PREVOST

WARRANTY BULLETIN

WB15-25

DATE :	MAY 2015	SECTION :	12 - Brakes
EXPIRATION:	MAY 2017		
SUBJECT :	POSSIBLE INTERFERENCE BETWEEN CLAMP AND SHOCK ABSORBER

Figure 1

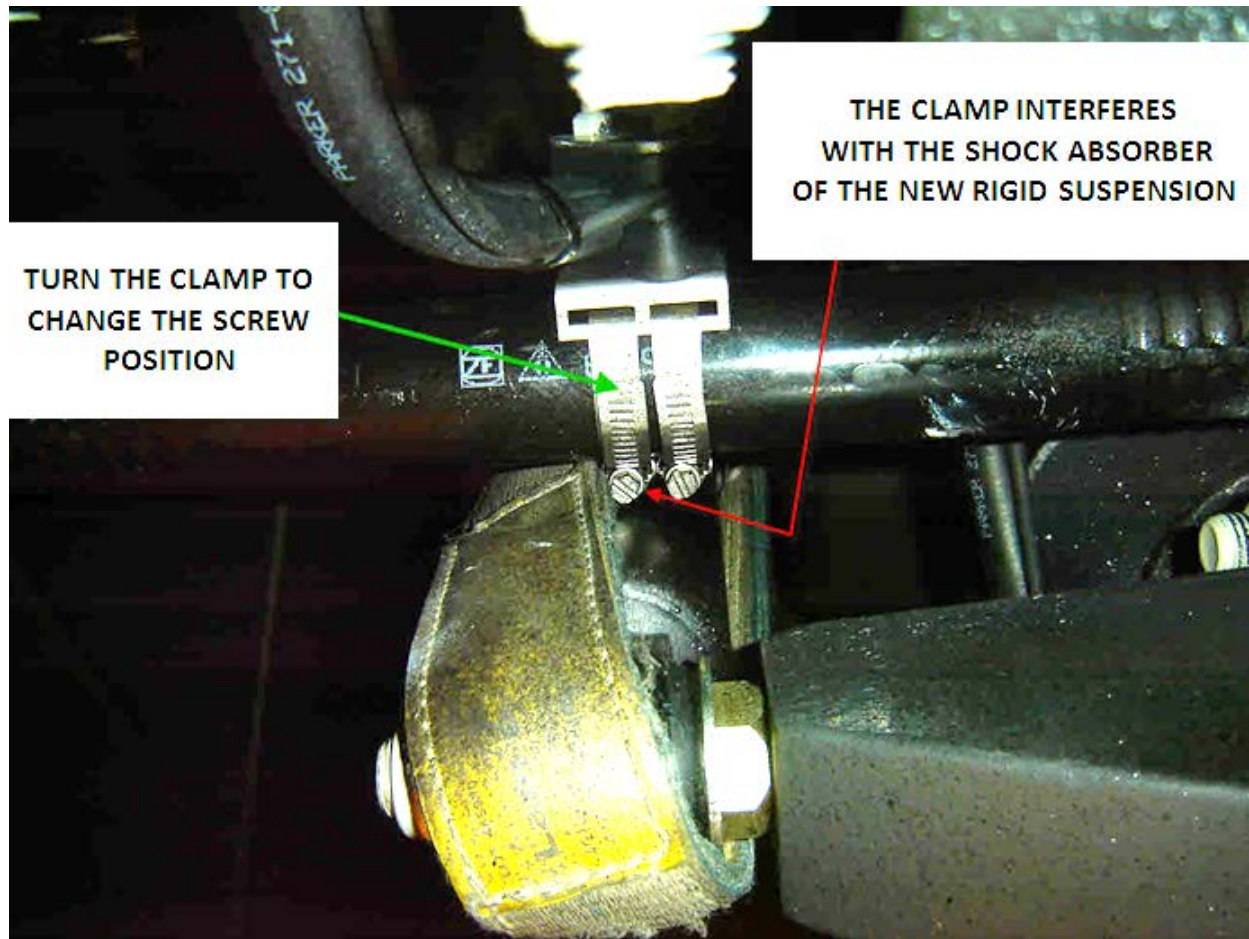
1. On each side of the vehicle, make sure that the screw housing on the clamps is not close to the shock absorber. If it is, slack and turn the clamps one at a time, away from the interfering region, to have the housing about horizontal.
